IMPORTANT SAFETY RECALL

Q-Tower 4 pack (part number 8000124) 2 pack (part number 8000135)

SAFETY RECALL NOTICE: NHTSA Campaign xxxxx

June 1, 2015

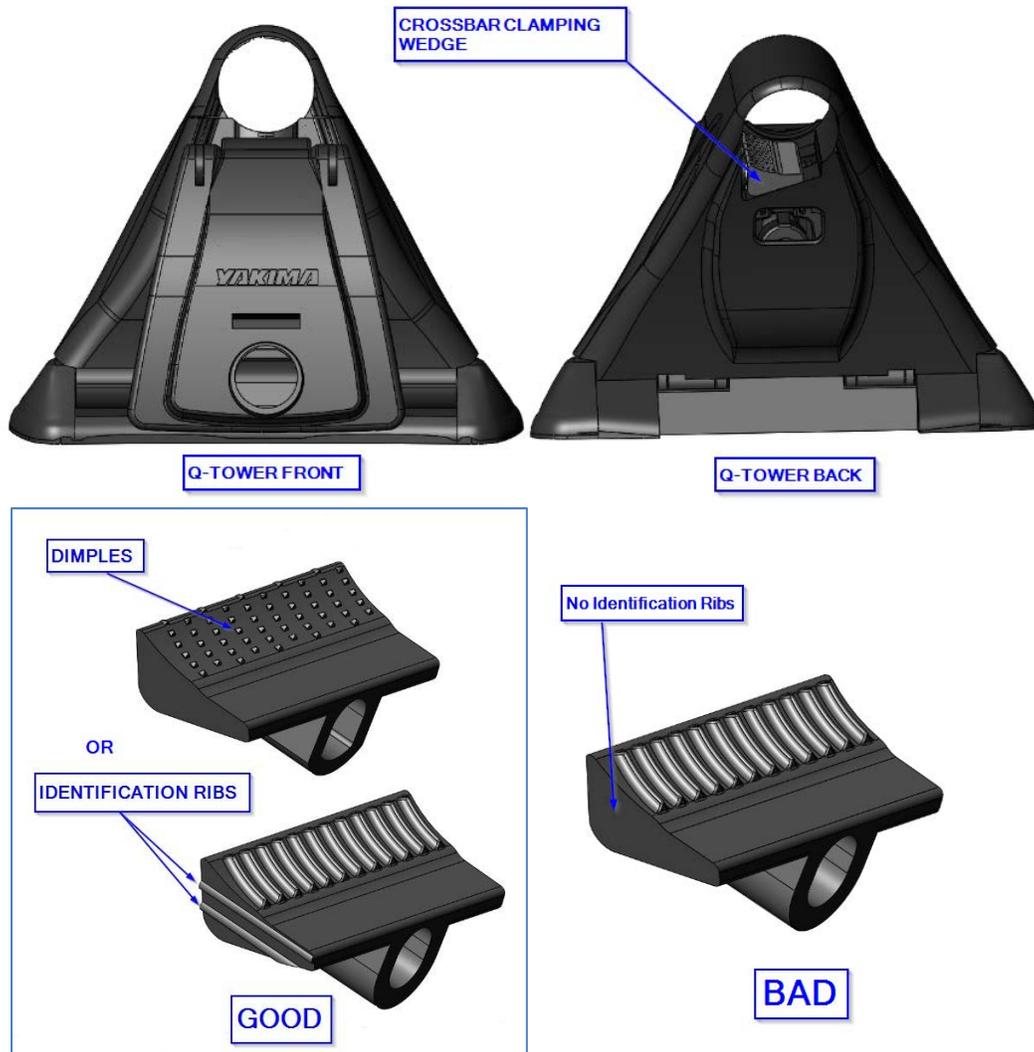
Yakima has determined that Crossbar Clamping Wedges installed on Q-Tower Roof Rack products manufactured between January 26, 2015 and May 26, 2015 may not meet minimum clamping requirements as specified in Yakima technical documentation. These Clamping Wedges could slide on the crossbars during installation causing a loose fit on the vehicle. Q-Towers sliding on crossbars can cause difficulties installing and/or compromise installed rack integrity. Prior warnings of this defect may include sliding or rattling noises when the Q-Tower rack is in use or identifying a loose fit during the required safety checks defined in the installation manual. A compromised fit could result in a rack ejection, causing a crash or personal injury to persons outside the vehicle.

Crossbar Clamping Wedges without the identifying characteristics are being recalled. If your Crossbar Clamping Wedges have the markings depicted as "Good" in the picture below, it is not affected by this recall. Affected products have a manufacturer's date stamp range of 5026 through 5146. The manufacturer's date stamp is found on the retail packaging on an end panel. Any manufacturer's date before or after these dates are not affected by this recall.

Yakima is asking that consumers contact Yakima Customer Service. The consumer is being asked to immediately remove and replace the Crossbar Clamping Wedges that Yakima will provide at no cost.
